**COMMUNITY DEVELOPMENT AUTHORITY MEETING  
CITY OF WISCONSIN DELLS  
MAY 7, 2018**

**FAÇADE IMPROVEMENT GRANT APPLICATION**

Staff Comment  
Façade Improvement  
DRC 05/16/18

Keg – 716 Oak.

# Proposed Awning

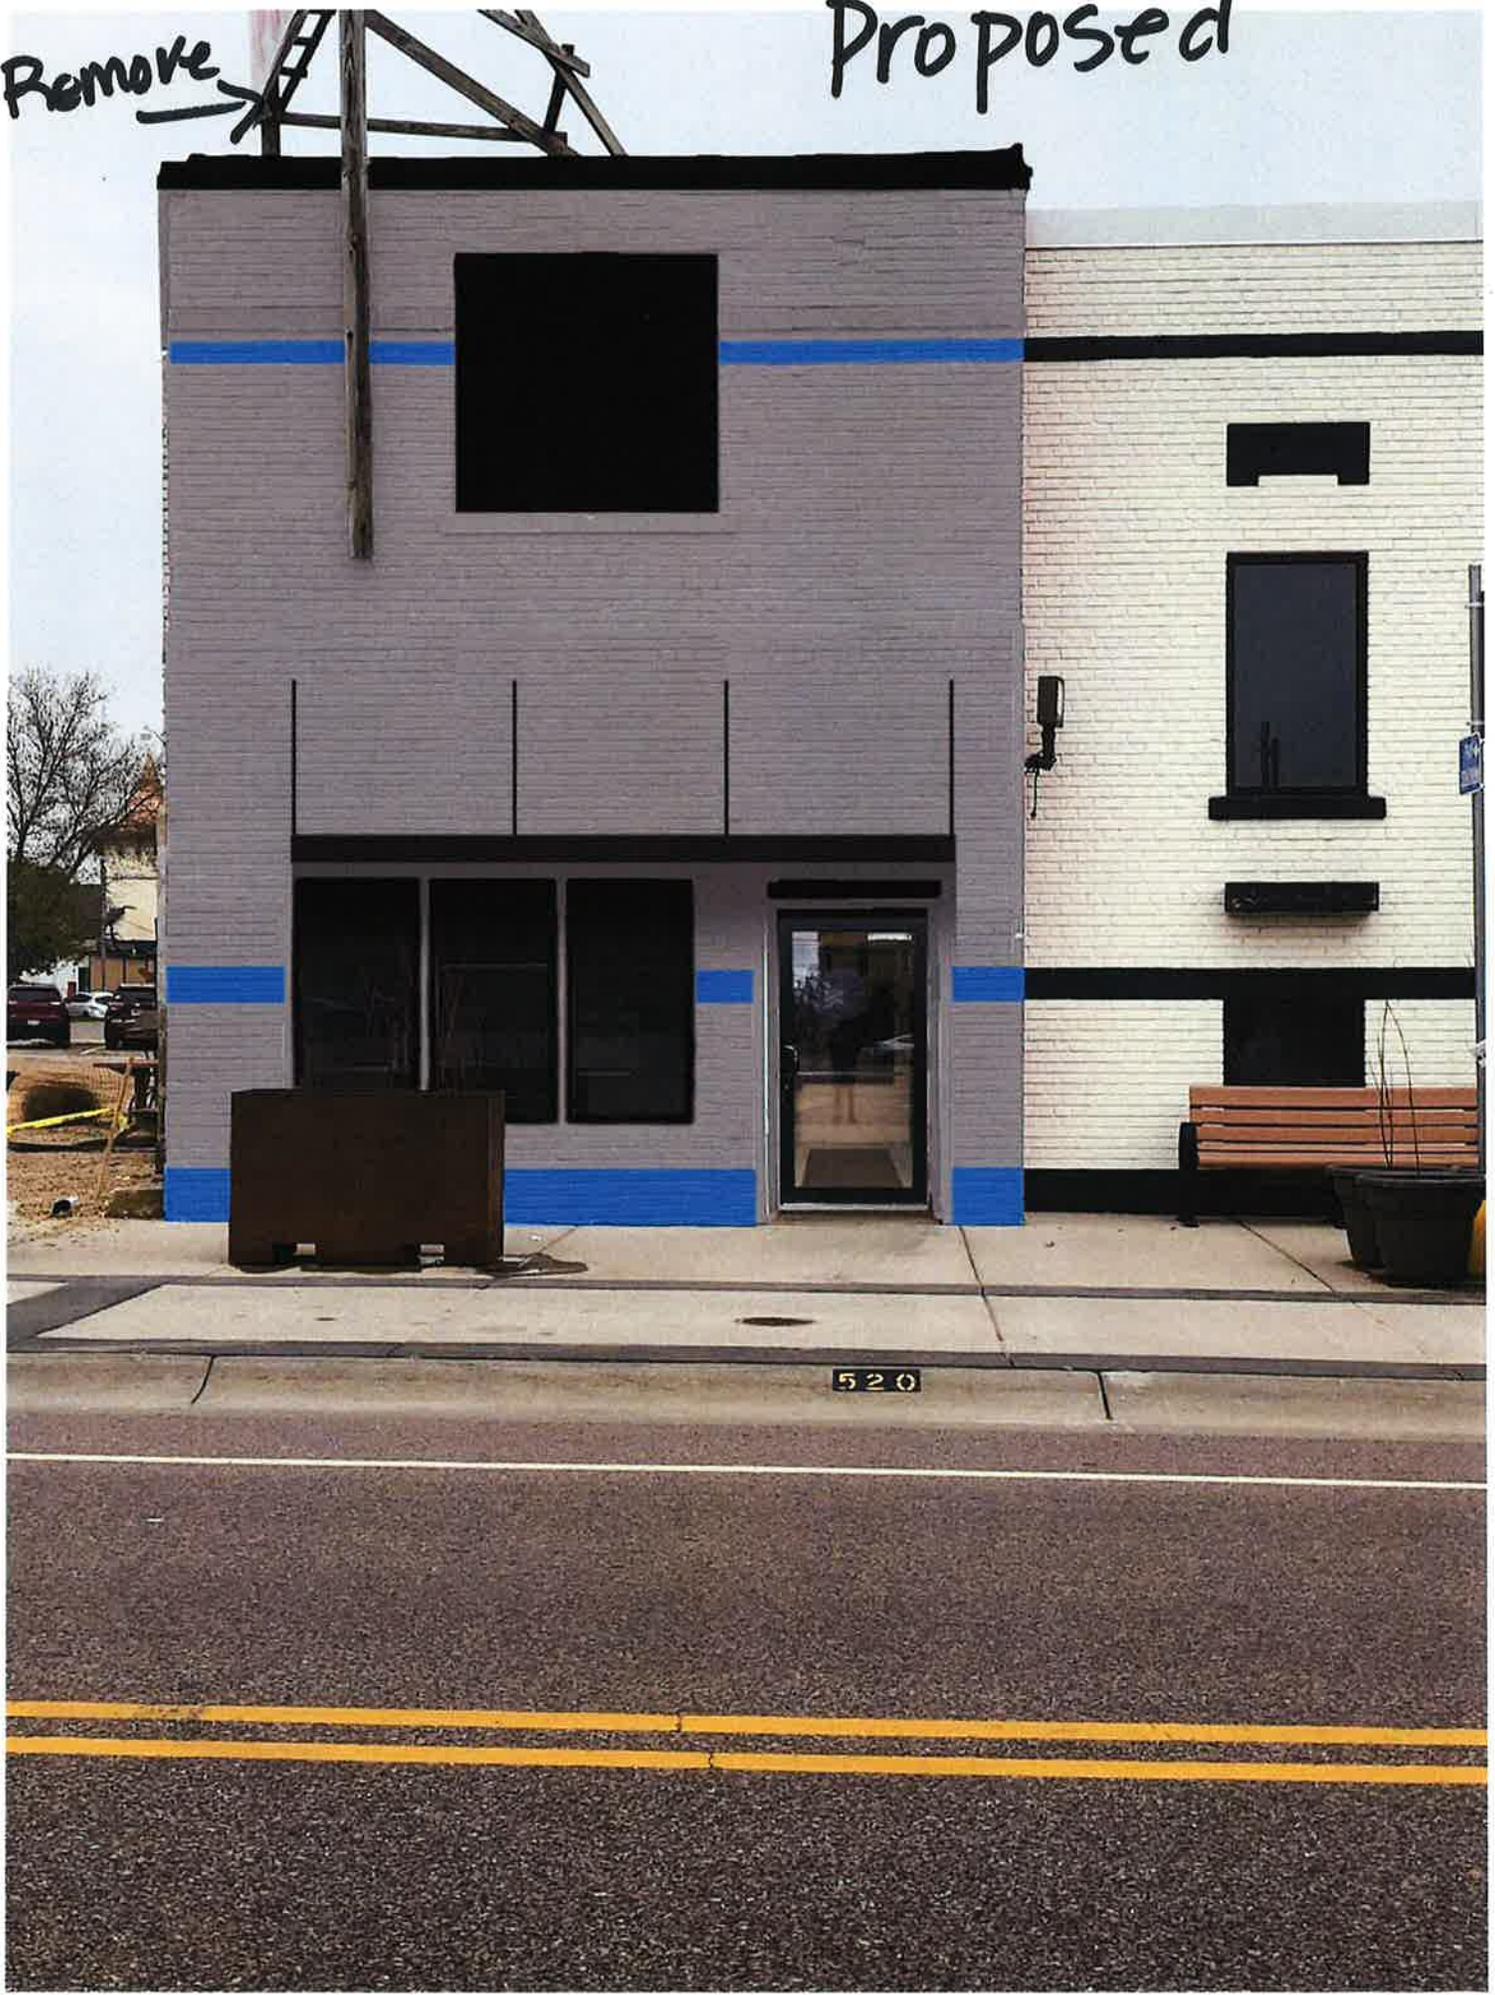
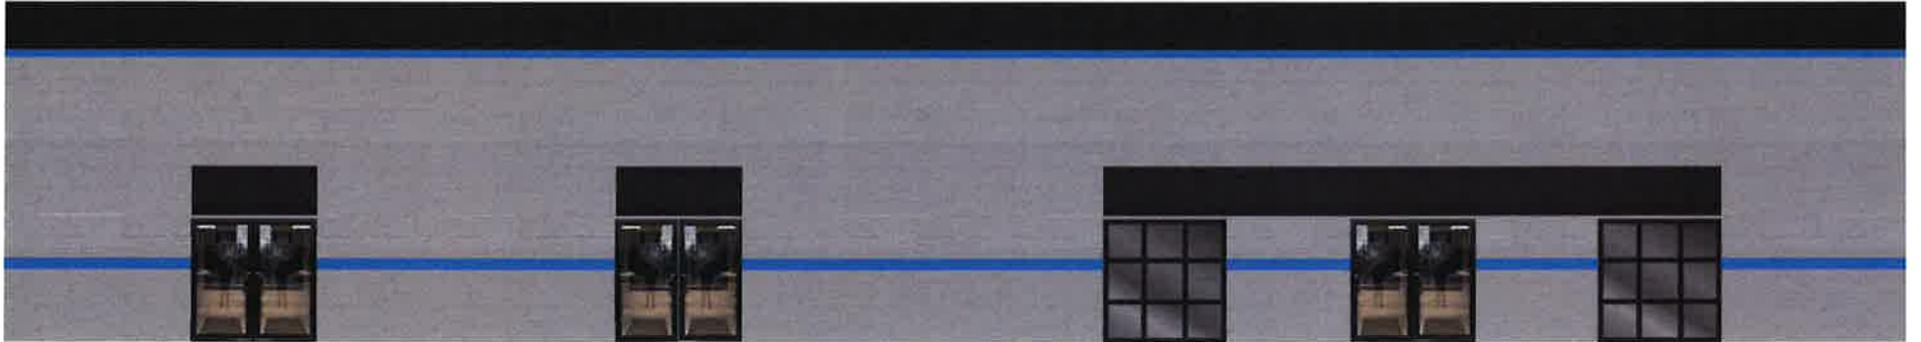
The City has received an application from Keith Koehler to improve the façade of the old All Time Sports building he recently purchased at 714 Oak. The proposal includes removing the existing wood paneling covering the lower portion of the Oak St. façade, exposing the upper floor window on the Oak St. façade that is currently covered by a sign, installing one new large black clad window to replace the row of 3 windows on the Oak St. façade, installing new glass doors on the north face of the building, installing new awnings above the windows and doors on both sides of the building, repainting the entire building, and removing the existing roof top sign on the building.

These changes would move this business closer in line with the Design Standards, specifically: the Standards do not allow signs to be mounted in front of windows; the Standards prefer exposed brick to wood paneling, the painted brick, the Standards prefer horizontal expression lines to transition between the first floor and upper floors, the standards prefer windows and glass doors to solid walls, the standards prefer the colors on the secondary façade to match the primary façade, the roof top sign does is exactly the type of installation the new standards would like removed.

Some additional items for consideration include: (1) providing a discernible base, which could be in the form of continuing the lower horizontal expression line at grade level; (2) providing a positive visual termination at the top of the building, which could be in the form of a black cornice to tie into the black roofing that is required on the side of the building.

It is noted that the black roofing material comes down from the top of the side of the building to cover penetrations in the brick that were used as pockets to hold the roof rafters for the old building that was removed. If these pockets are not kept weather proofed the interior and exterior of the building could quickly degrade.

It is also noted that the roof top sign is tied into the existing rubber roof and the current plan is to re-roof the building in the fall. The roof top sign would be removed as part of the re-roofing project to prevent leaving holes in the roofing that could allow water to enter the building. If approved for a façade improvement grant, the applicant understands that the project would not be complete until the roof top sign is removed, and therefore will not be eligible for grant payments until the roof top sign is removed. Grant projects must be completed within 6 months, and the applicant stated he will meet that schedule.

The applicant has stated he intends to install a wall sign facing Oak St. near the corner of the building. It is an existing Keg sign that is no longer in use. The background of the sign had a blue hue to it. The blue horizontal expression lines on the building are meant to compliment that color.
